PARKSIDE MONTESSORI MPR AND SITE PROJECT

ADDENDUM NO. 4

Date: November 21, 2023

Project: Parkside Montessori MPR & Site Project
DSA #: 01-120306 41-26

SHEET NAME:
MATERIALS AND CONSTRUCTION
DETAIL REFERENCE PLAN

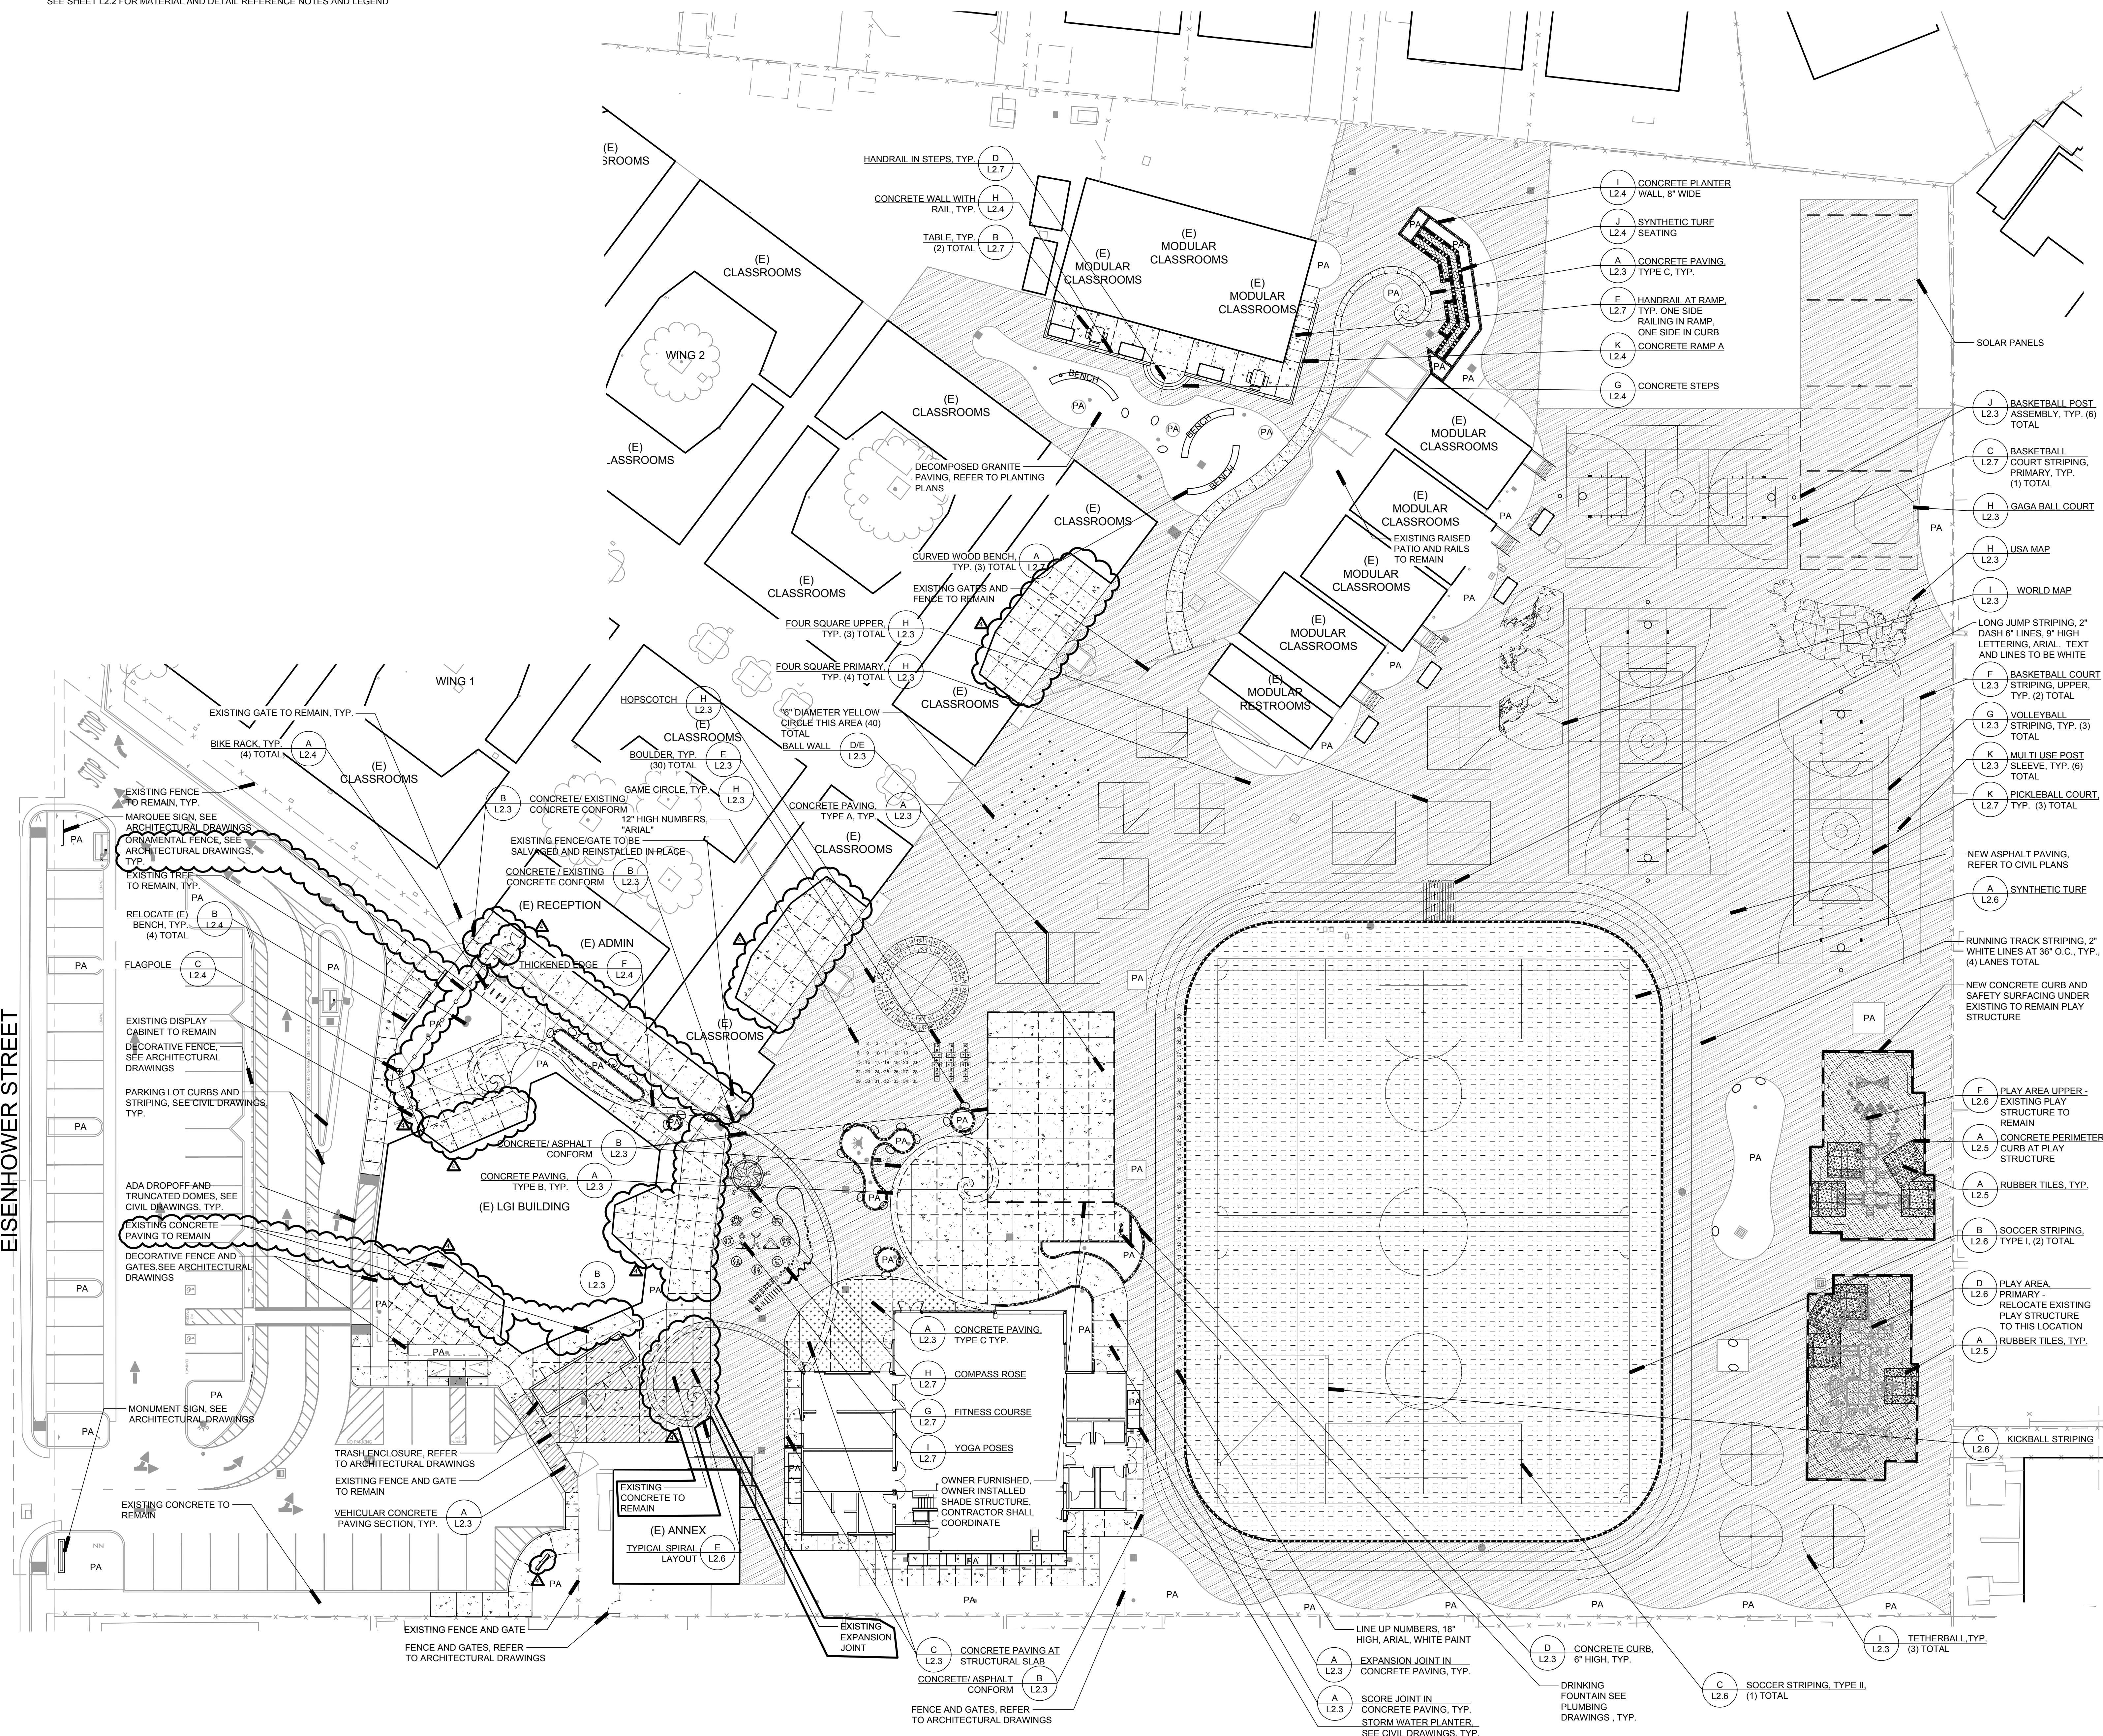
8. **SHEET ‘L2.1 MATERIAL AND DETAIL REFERENCE PLAN’**

- A. Added new layout of ornamental fence between LGI and Admin.
- B. Changed location of 4th Salvaged Bench.
- C. Added additional flatwork around LGI.
- D. Added additional flatwork by Admin.
- E. Added additional flatwork by existing Classroom Wings.
- F. Added additional flatwork north of new MU Building.

Q: Sheet L2.1 calls out for "Decorative Fence, See Architectural Drawings" in the landscaping area between the parking lot and EVA Drop Off Lane. Architectural sheet A1.2 which has all other fences called out does not mention any fencing in parking lot. Please confirm which is to be correct and update accordingly.

Q: On Sheet C2.1 and on sheet L2.1 at the area in front of the new MPR Building kitchen, the pattern for Decomposed Granite is shown however the keynote callouts on both of these sheets are for concrete paving at this location. Please confirm which paving will be required for this area and update accordingly.

A: Refer to Landscape Drawings and add 4' high black vinyl-coated chain link fence in lieu of "decorative fence". Sheet A1.2 correction is issued in this Addendum 4.

A: The "cross" hatch shown in front of the new MPR Building kitchen on sheet L2.1 should be keyed to the legend on sheet L2.2. The "cross" hatch shown on sheet L4.1 should be keyed to the legend on sheet L4.2. On sheets L2.1 and L2.2 it denotes "Concrete Paving Type 'C'" but on sheets L4.1 and 4.2 that hatch denotes "Decomposed Granite Paving". The hatch for the "Decomposed Granite Paving" has been removed from sheet L2.1 for graphic clarity.

L2.2

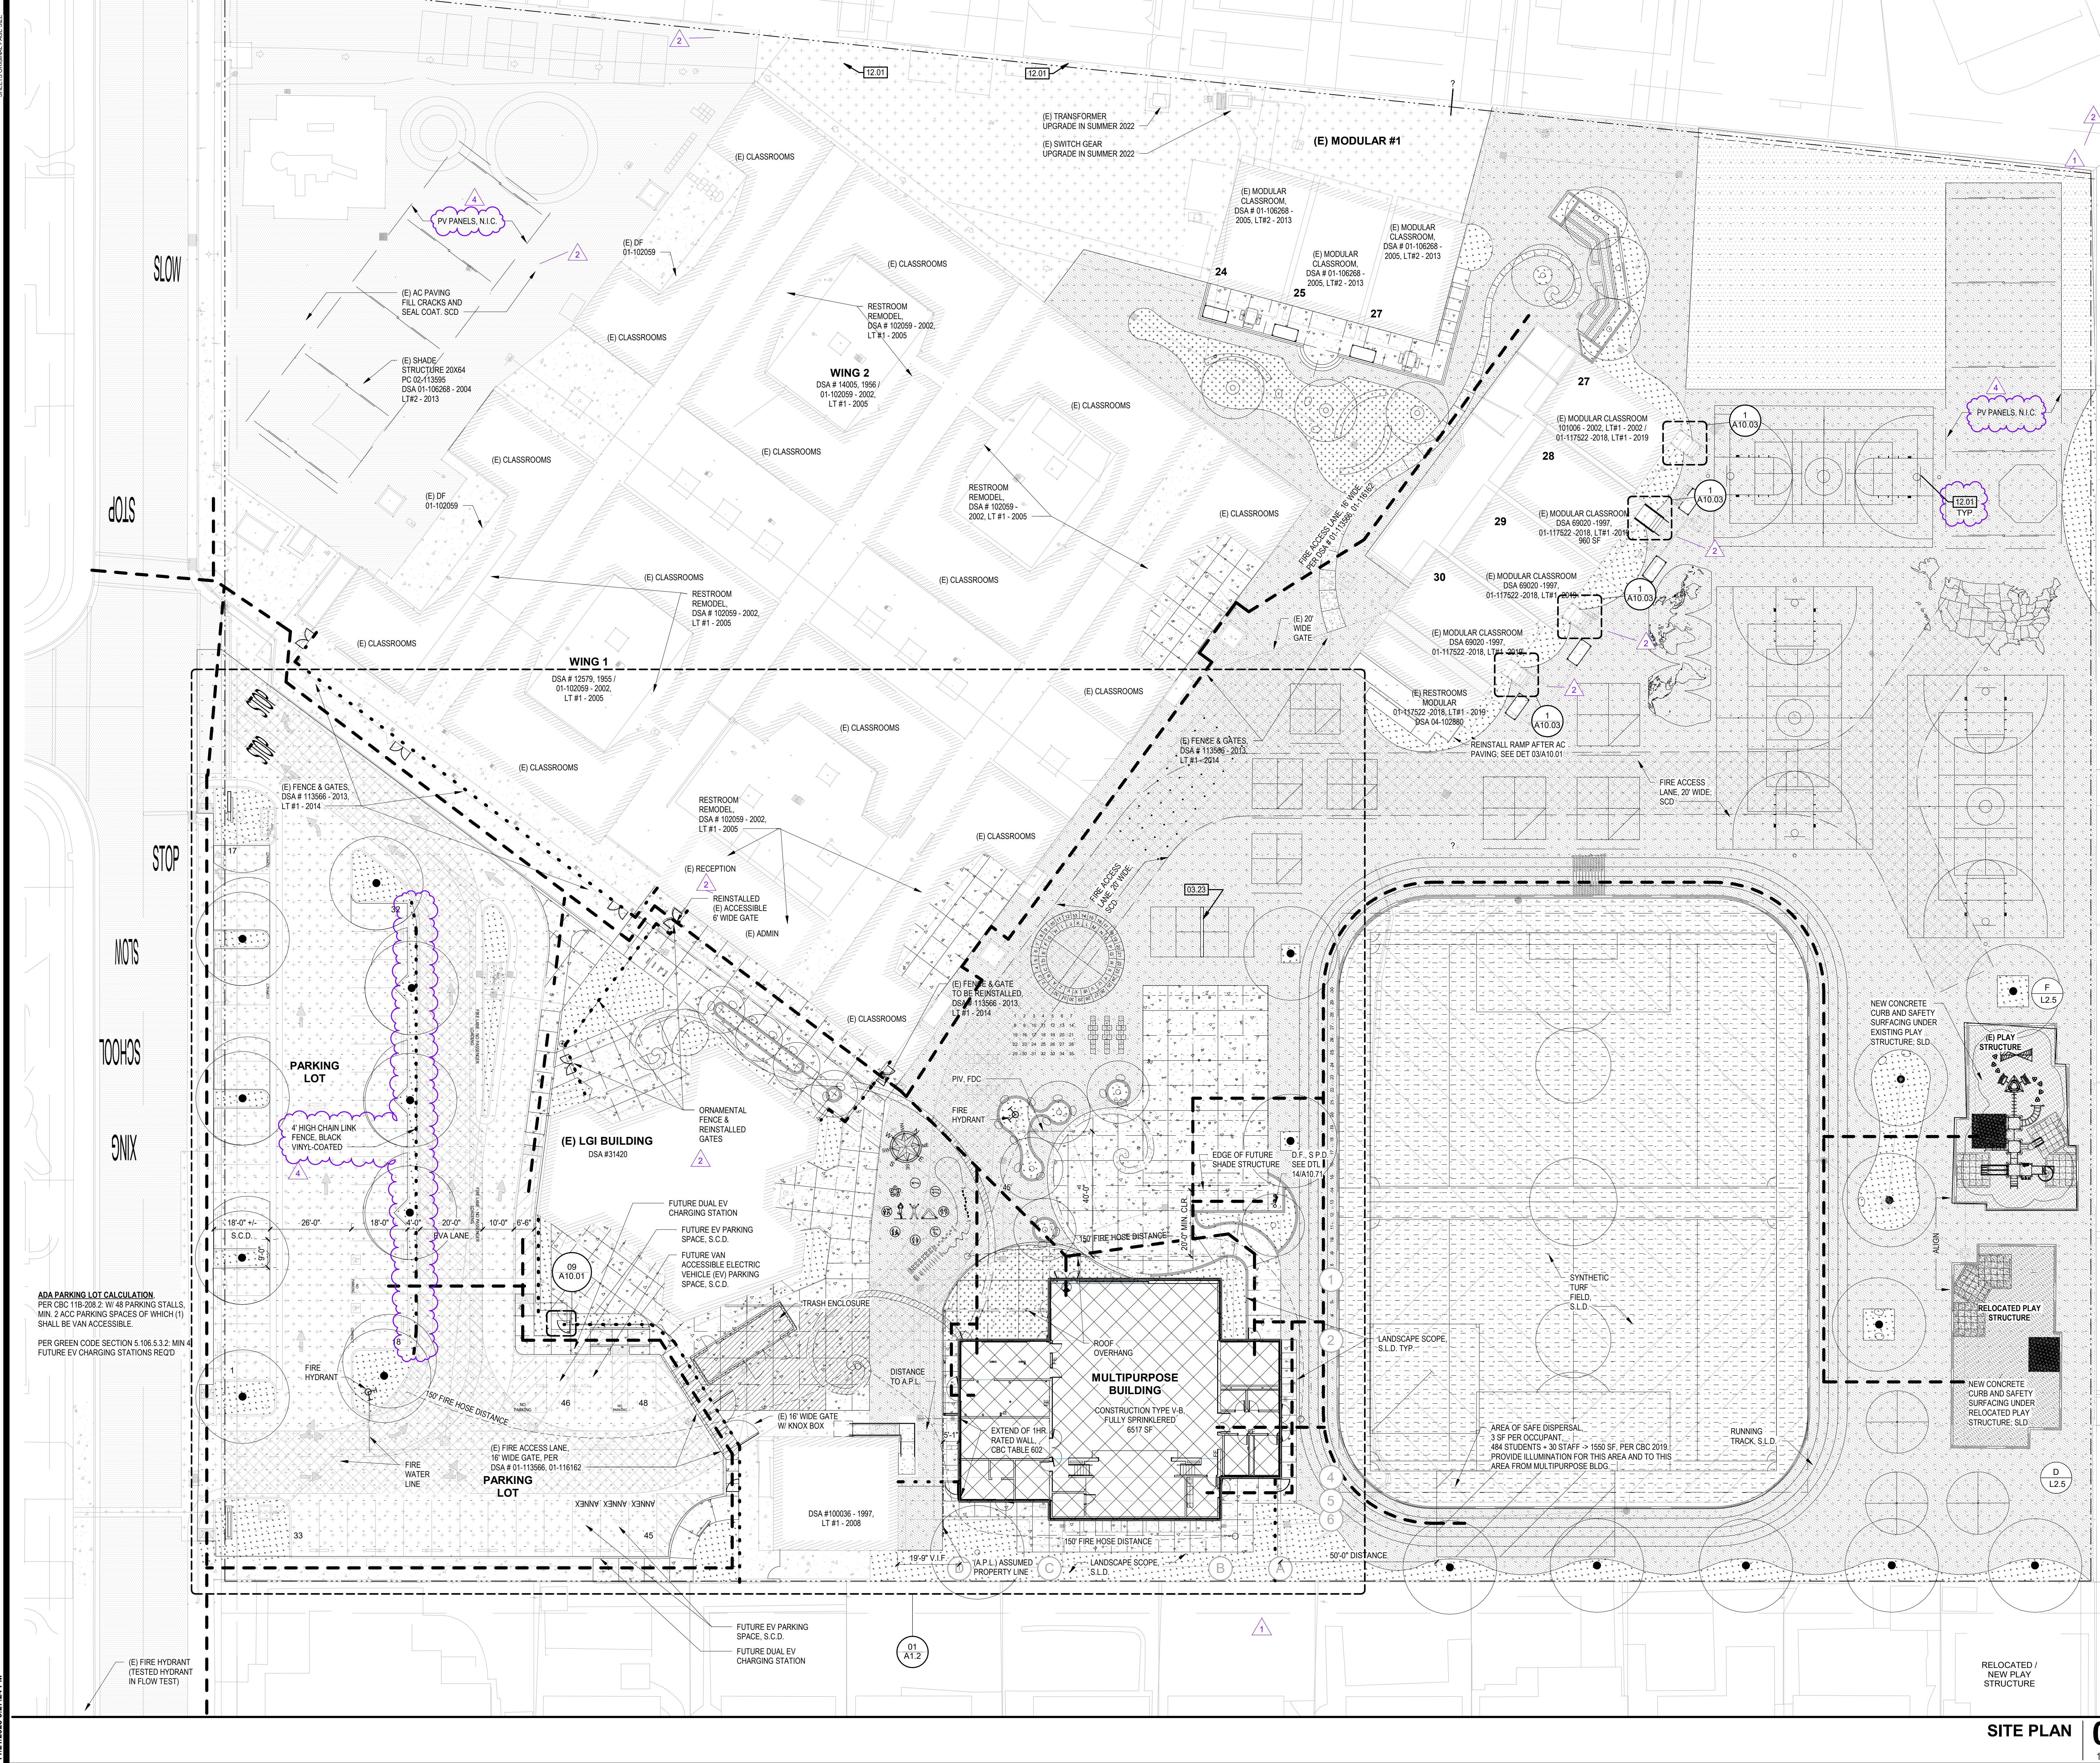
9. SHEET ‘L2.2 MATERIAL AND DETAIL REFERENCE PLAN’

- A. Added entry into Material and Detail Reference Legend for the ornamental fence.

1 ELECTRICAL - SITE PLAN

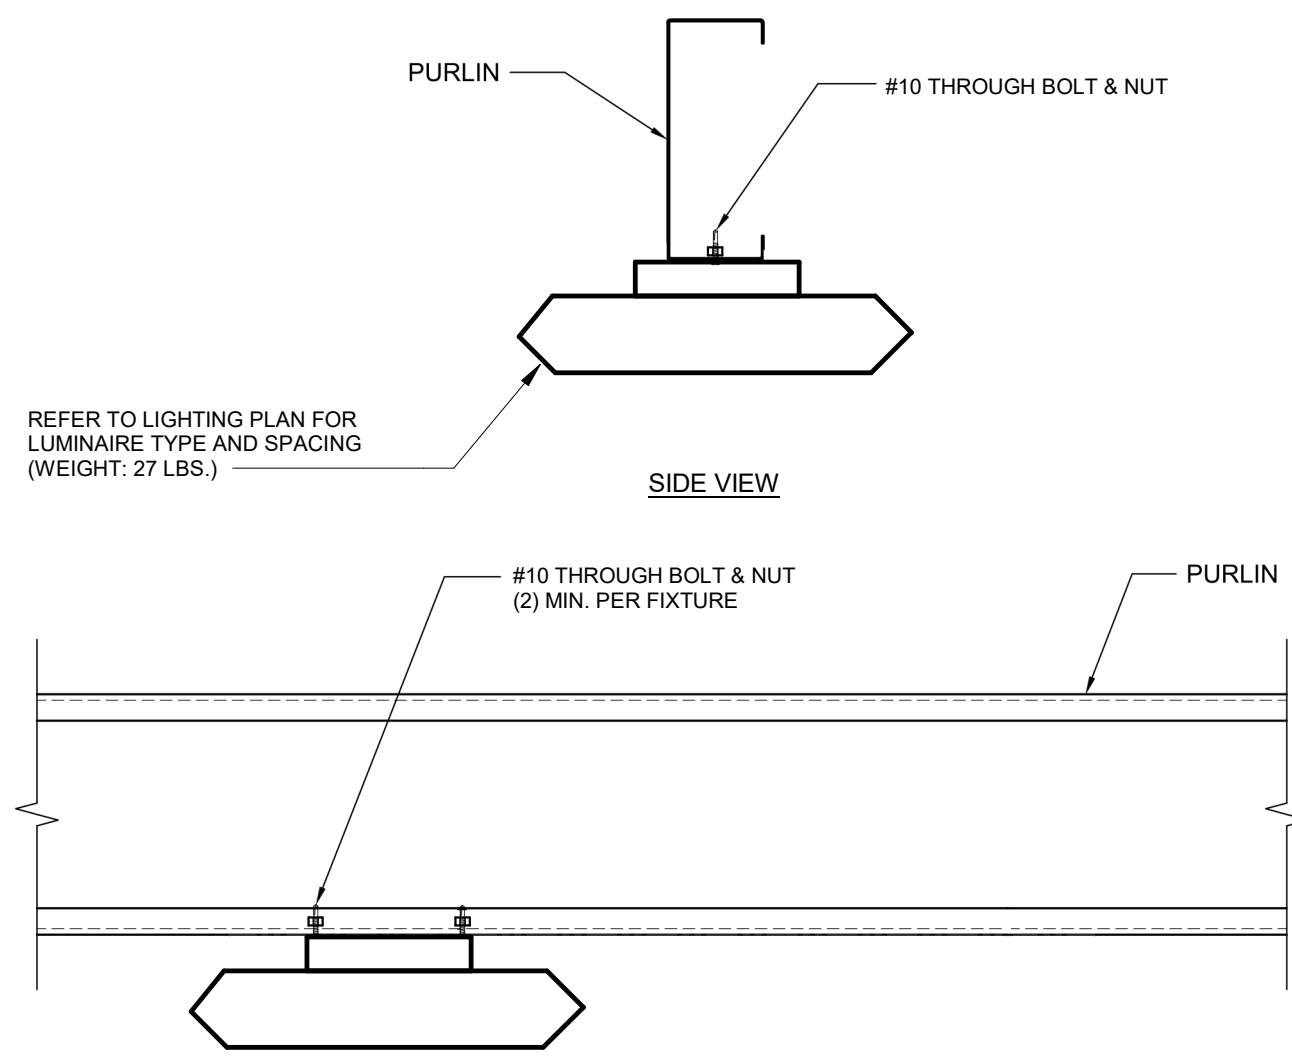
15. SHEET ‘E1.1 ELECTRICAL SITE PLAN’

- A. Updated plan to show location of N.I.C. lunch shelter.
- B. Added callout 1/E1.1A.
